Brisbane Central Business District Bicycle User Group

The Brisbane Central Business District Bicycle User Group (CBD BUG) continues to be deeply disappointed that through the current plans for the Metro your administration plans to downgrade bicycle access across the Victoria Bridge.

Figure 7.2: Path widths for a 50/50 directional split

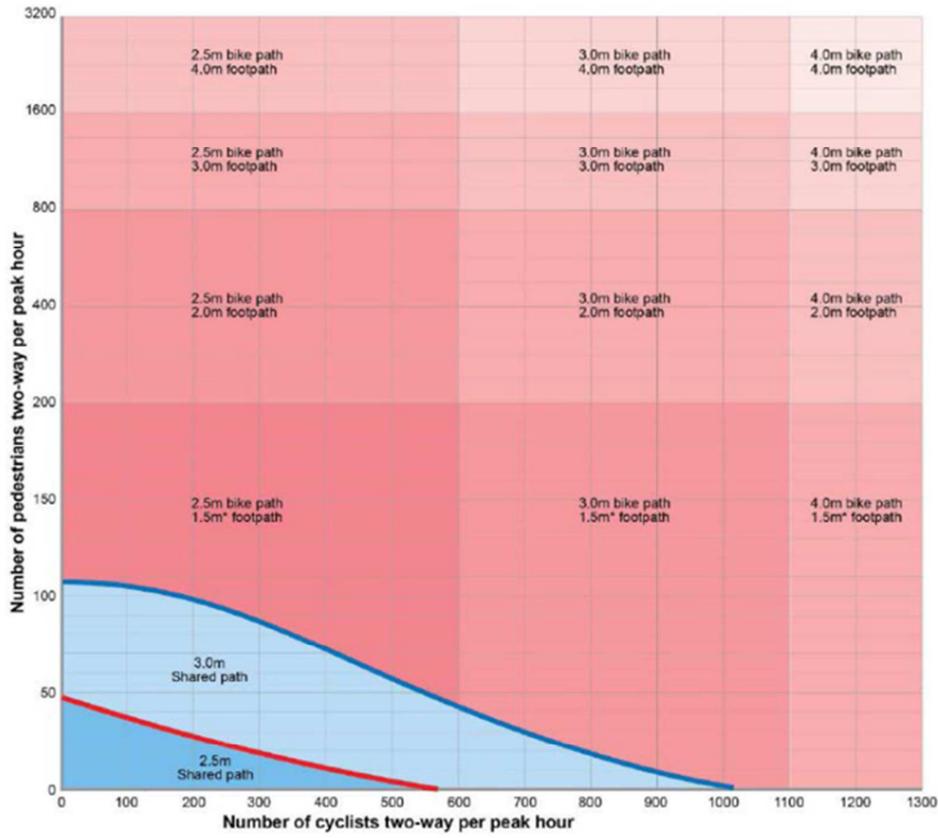
The CBD BUG would like to point out that the current unfavourable cycling conditions for those using the Victoria Bridge factor into this patronage figure. In addition, the Cycling Aspects of Austroads Guides 2017¹ (quoting the Queensland Department of Transport and Main Roads' "Road planning and design manual" (2015)) provides guidance for path types and widths for given pedestrian and cyclist volumes. It is shown in Figure 1 in this letter. We note that the Victoria Bridge in 2015 (Data Audit Systems count)² had Thursday peak hour counts of 61 cyclists and 2,007 pedestrians in the 5 pm to 6 pm period. It is absolutely clear from Figure 1 that no matter what the directional split, a 2.5 metre wide shared path, as planned, is completely inappropriate for this pedestrian volume.

The CBD BUG has received reports of pedestrian-cyclist conflict on the bridge. Council's Active Transport Plan envisages that cycling will more than double to 5% of all trips by 2026, which will require a concomitantly higher growth in inner Brisbane. Based on the charts, a wider separated footpath and bike path will be required due to this active transport growth.

Thus, for Brisbane City Council to proceed with the 2.5 metre shared path option will only lead to more pedestrian-cyclist conflict. This will lead to hazards for both walkers and people riding bikes. This flagrant disregard for guidelines will expose Brisbane City Council to legal liability for the conflicts that will inevitably occur because of this poor planned design.

Figure 2

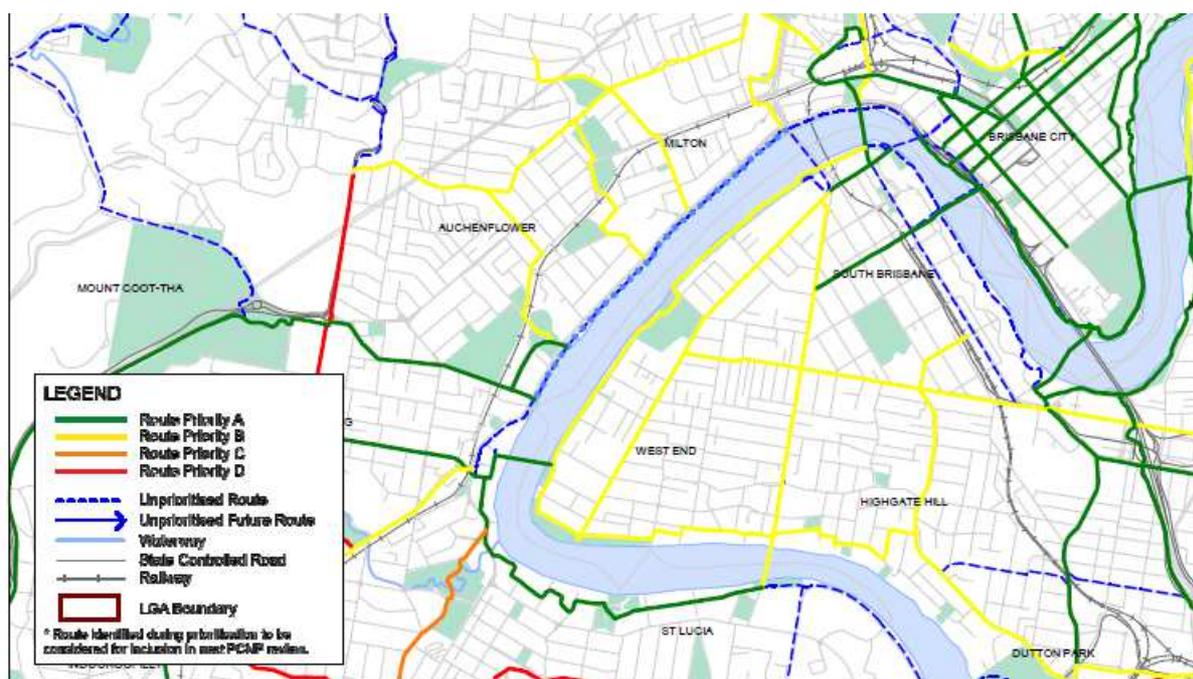
The CBD BUG does not accept the assertion that current patronage figures are an acceptable reason that the Victoria Bridge should not be adequately provided with cycling facilities. The CBD BUG's view is backed by the TMR document "Priority Routes Map – South East Queensland – Addendum to Principal Cycle Network Plan, 2017" (please see figures 2 and 3). This lists the Victoria Bridge location and indeed the Melbourne Street corridor as a "Route Priority A" with a "focus of delivery in the next 10 years".

In light of this document the CBD BUG would like to enquire how Brisbane City Council intends to achieve this State Government proposal; or has the Brisbane City Council chosen to ignore this planning document?
